**WILLIAMS LAKE DAM**

MA. 00451

**PHASE I INSPECTION REPORT  
NATIONAL DAM INSPECTION PROGRAM**

NATIONAL PROGRAM OF INSPECTION OF NON-FEDERAL DAMS  
DRAFT REPORT REVIEW COMMENTS

Appendix C

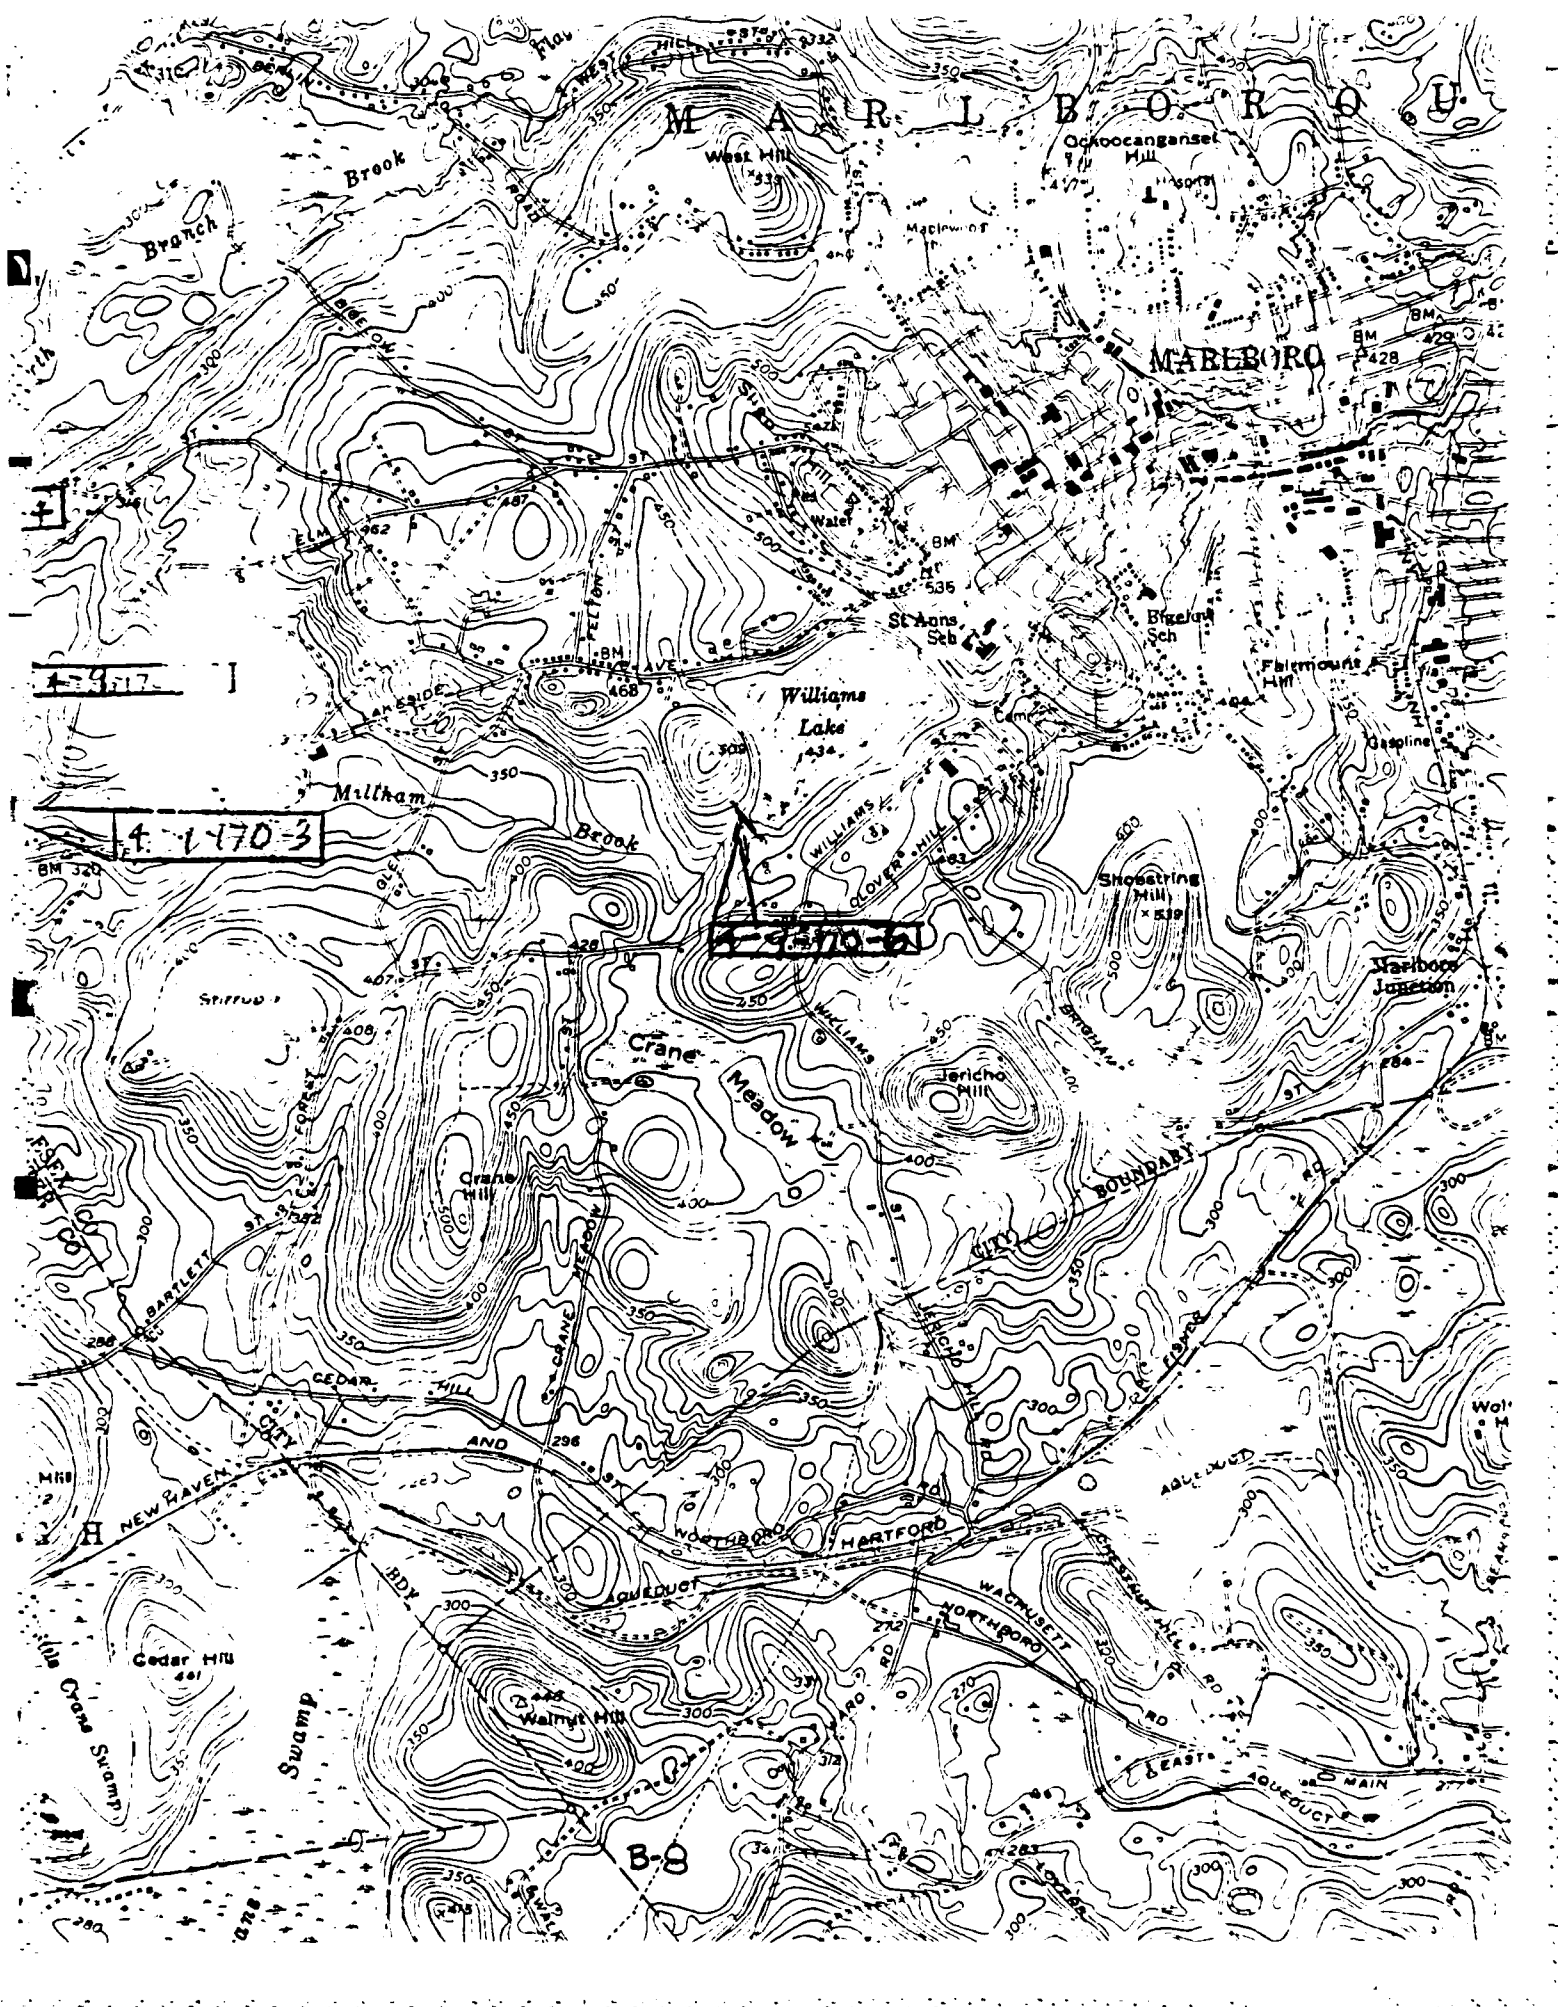
8	Par. 3.1 c : Discuss clarity of seepage.
Section 3	General : Photos may be referenced incorrectly. Have no photo 4 or photo 5. Ref. to 5 sounds like 3.
15	7.2 (3) : Reword statement as follows " Design and construct a means to safely drain the lake." or something similar to this. The need for this is already evident.
	7.2 (5) : Include trees <del>on the crest and</del> within so many feet of the toe. Eliminate brush.
16	7.3 : Include a recommendation to remove all brush and debris from the dam and spillway, and within so many feet of the toe.
General	Is the dam presently used for water supply or is it just one of the city's options for emergency water supply if needed?
